Date: **March 9, 1998**

Subject: **MOMENTARY HORIZONTAL NOISE**

Model: **PVM-8040, PVM-8041Q, PVM-8044Q**
PVM-8043MD, BVM-8044QD

Figure 1

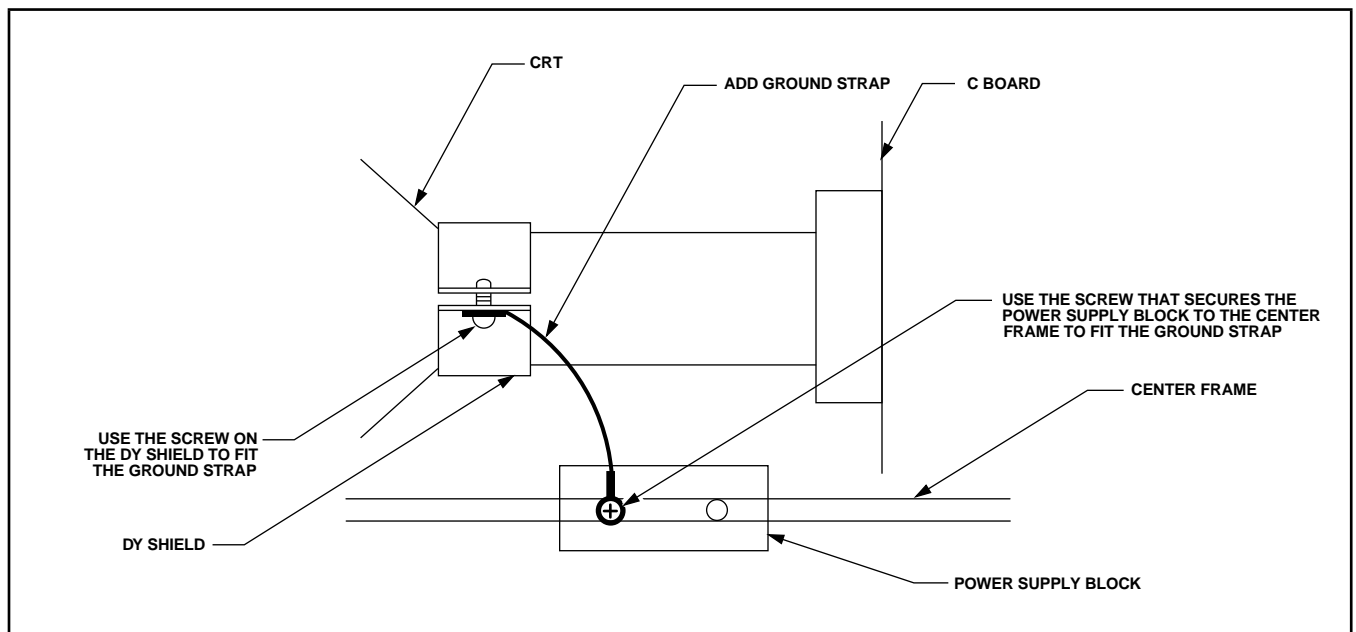
Static electricity on the DY shield may cause horizontal noise to be displayed. To correct this condition perform the following modification.

Fit a ground strap between the DY shield and the center frame as shown in Figure 1.
